GRANDVIEW RESERVE

GEICK RANCH TRIBUTARY 2

CDR-228

CONSTRUCTION DOCUMENTS
TITLE SHEET

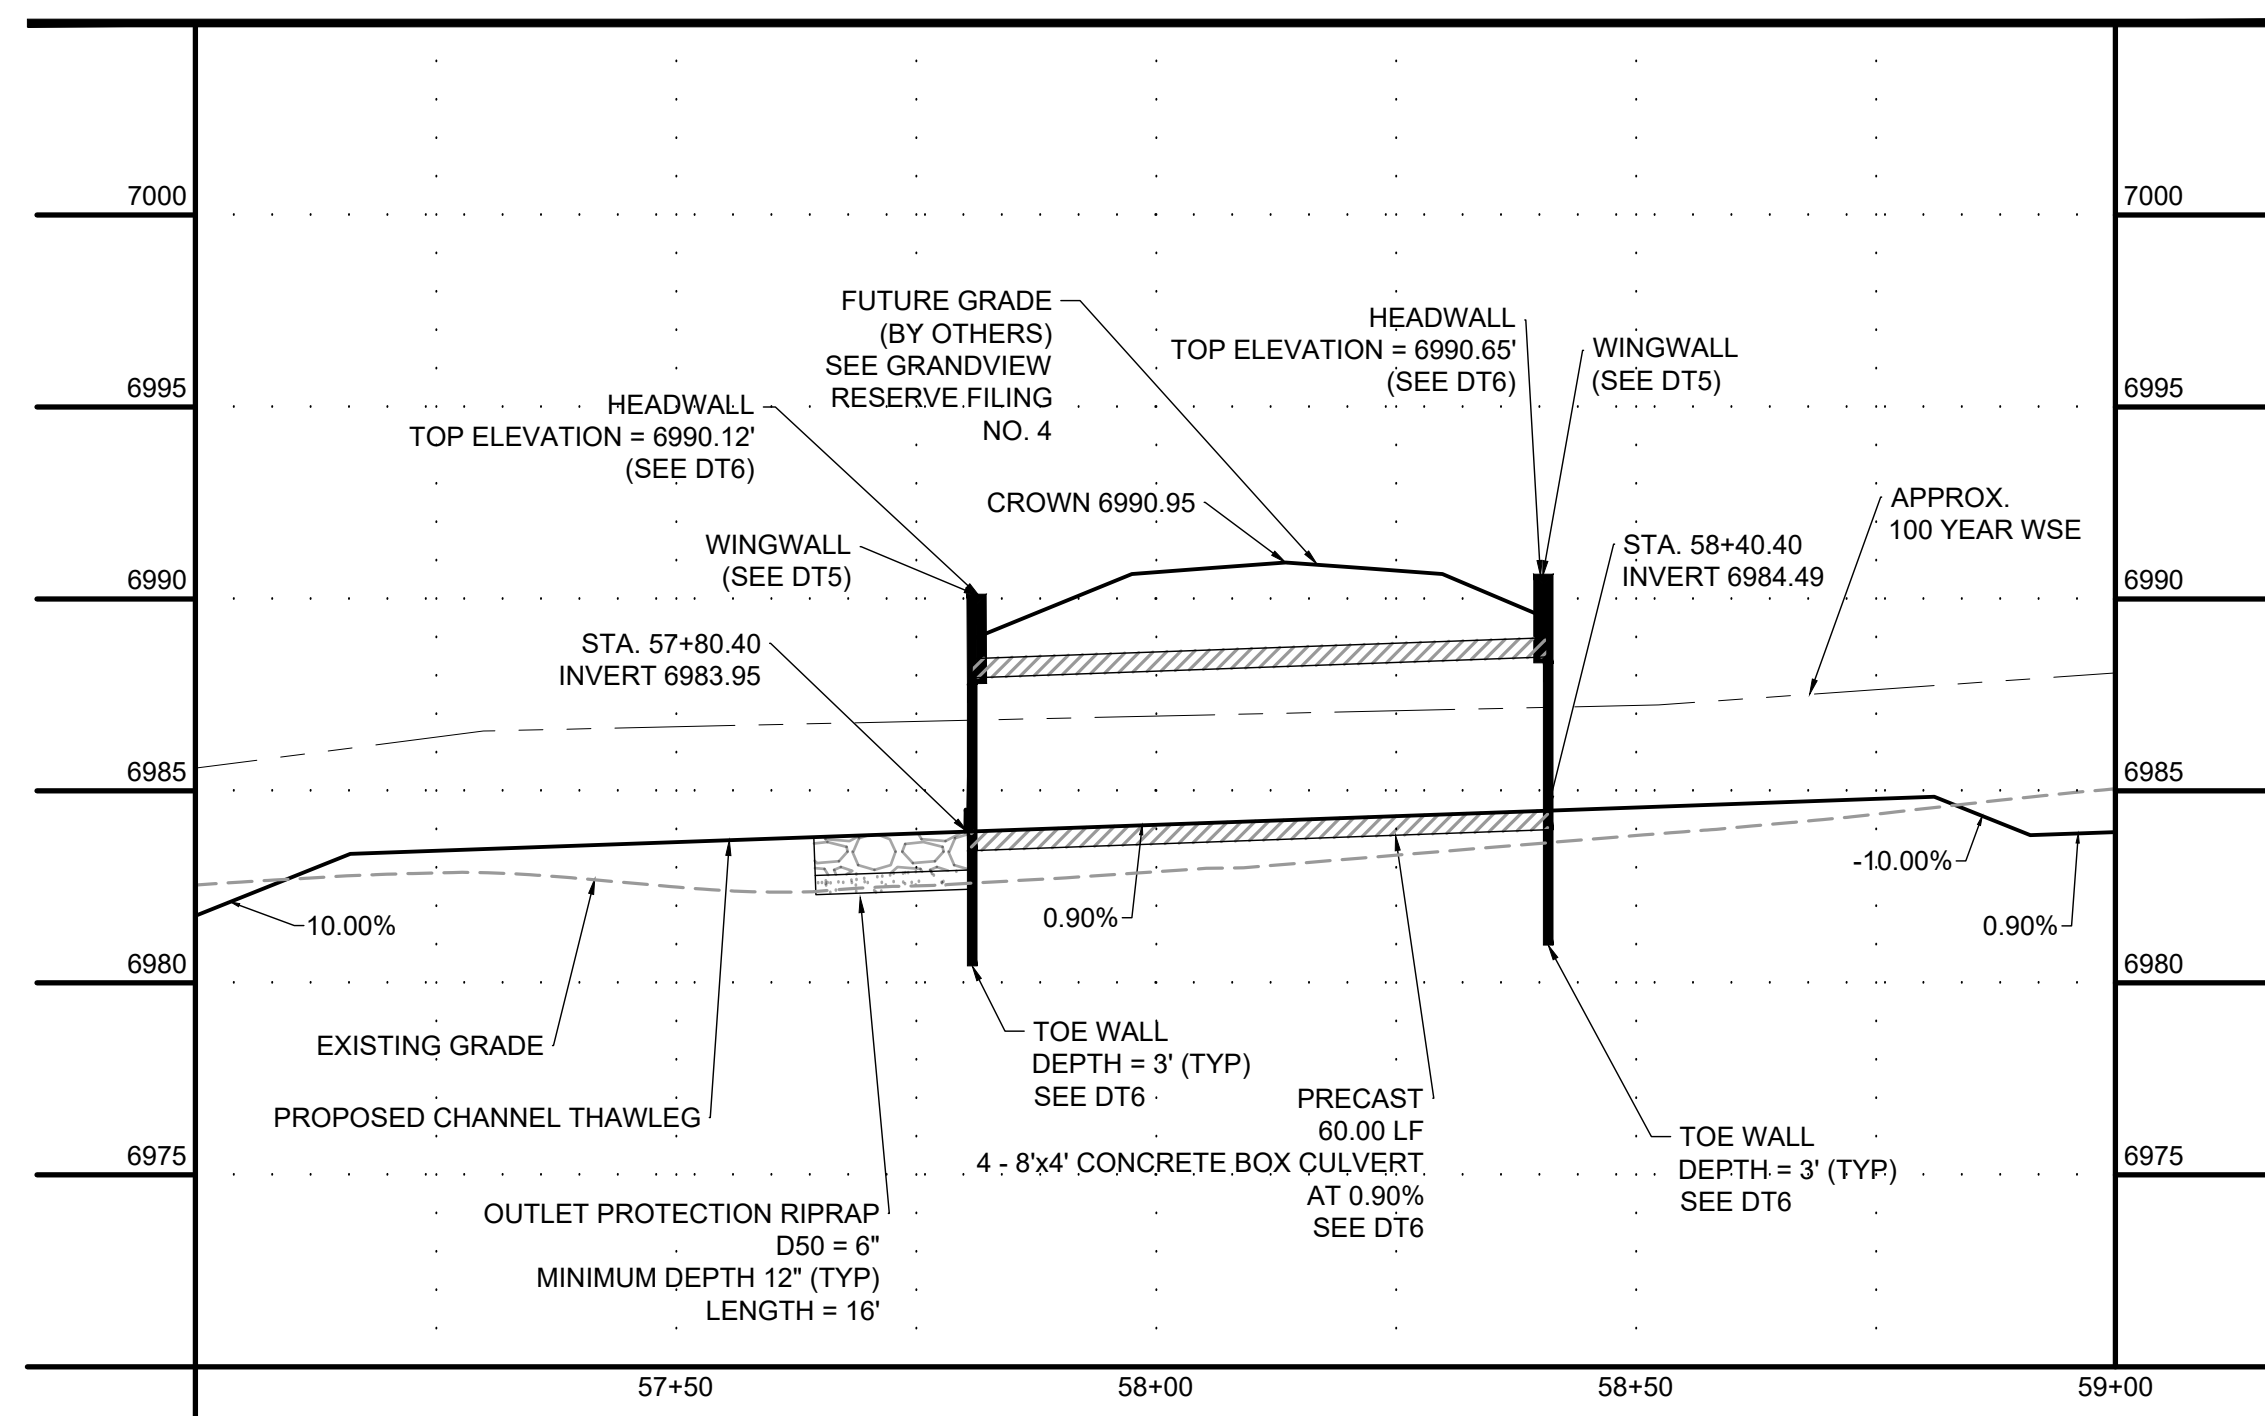
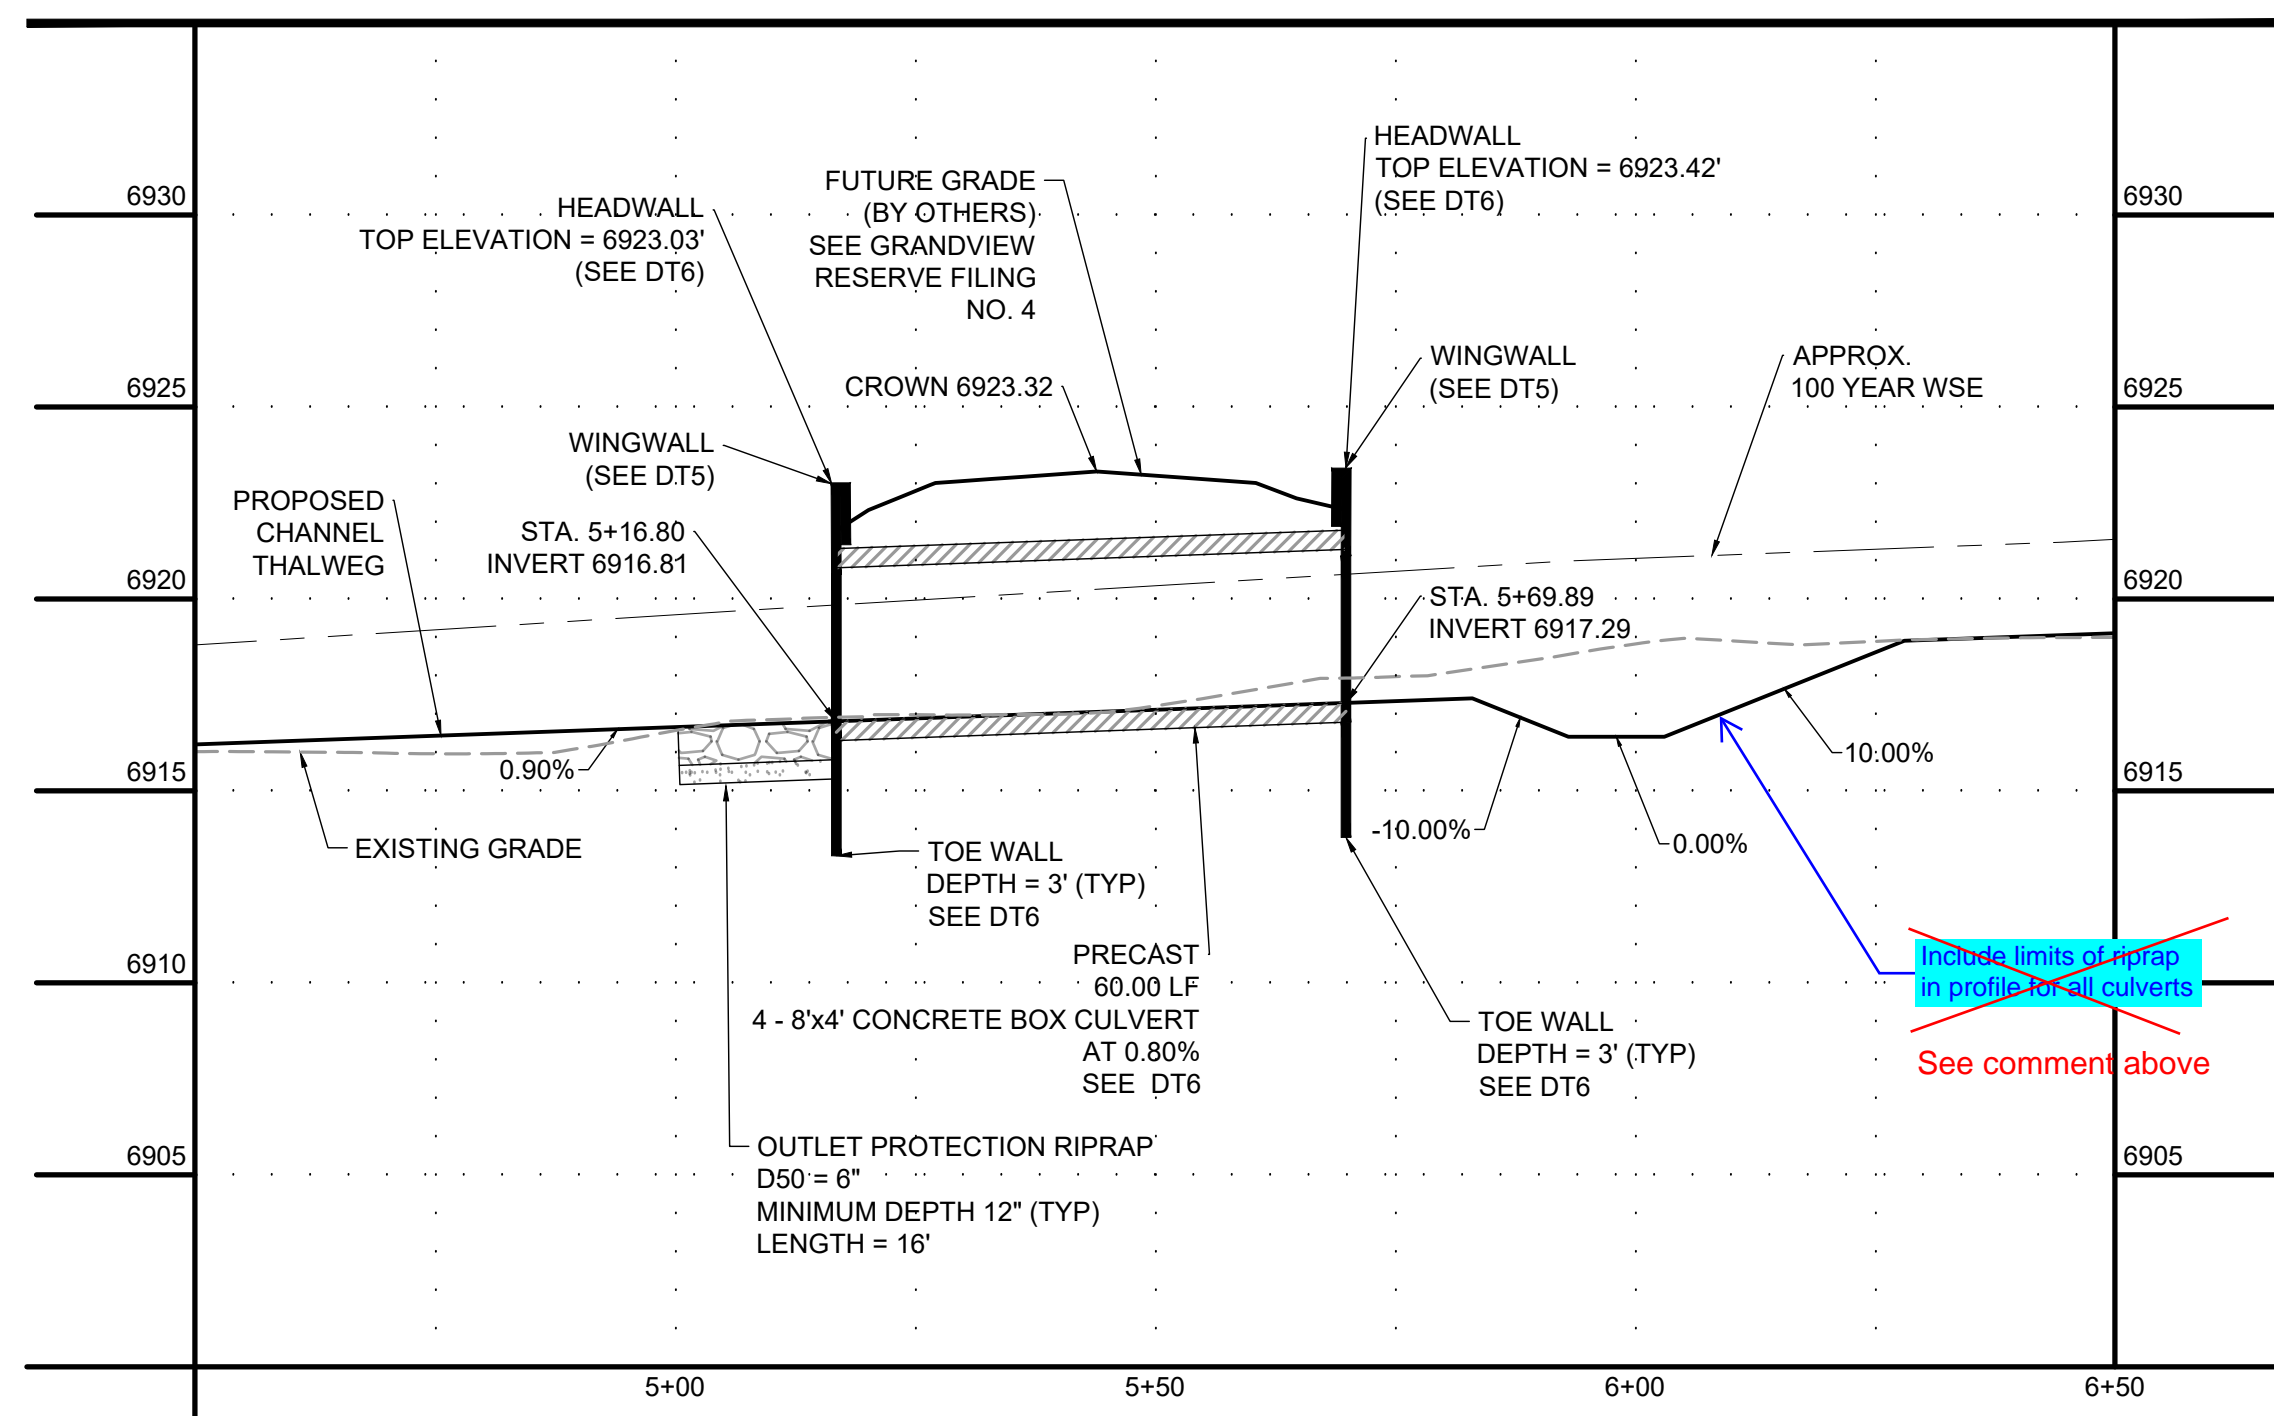
- WING WALL. SEE SHEET DT5 FOR DETAILS** (multiple locations)
- INLET PROTECTION OF APRON NEEDED?** (highlighted in red)
- TOE WALL PROVIDES THE BUOYANCY AND SCOUR PROTECTION NEEDED** (highlighted in red)
